Starkist Samoa Co. August 15, 2019
Comments on Public Notice Draft Permit NPDES No. AS0000019

Starkist Samoa Co.
August 15, 2019 Comments
Public Notice Draft Permit
NPDES AS000019

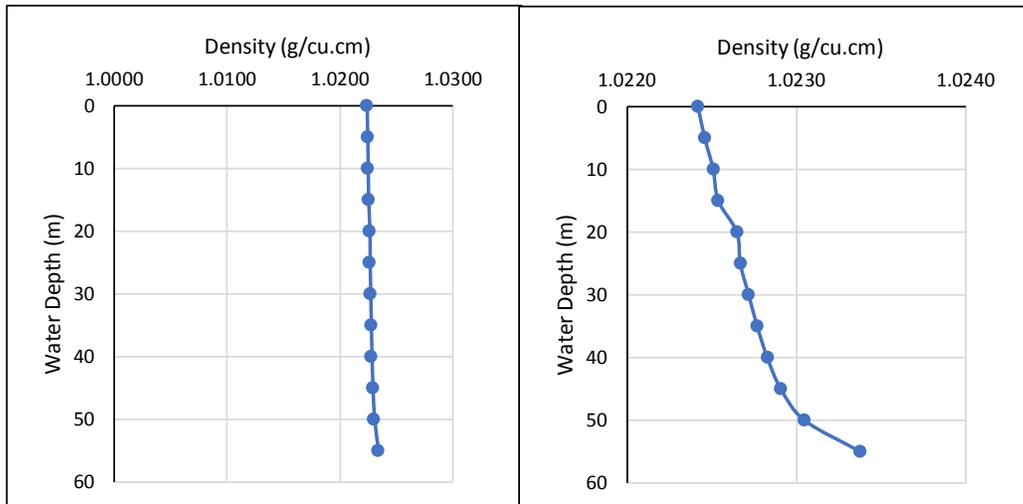
7. US EPA's selection of a depth of 5.2 meters below the water surface as the depth at which water quality standards must be met is arbitrary and without apparent basis or reasonable explanation. Further, if a set of model scenarios has been performed, a range of dilution values would have been predicted at this depth.
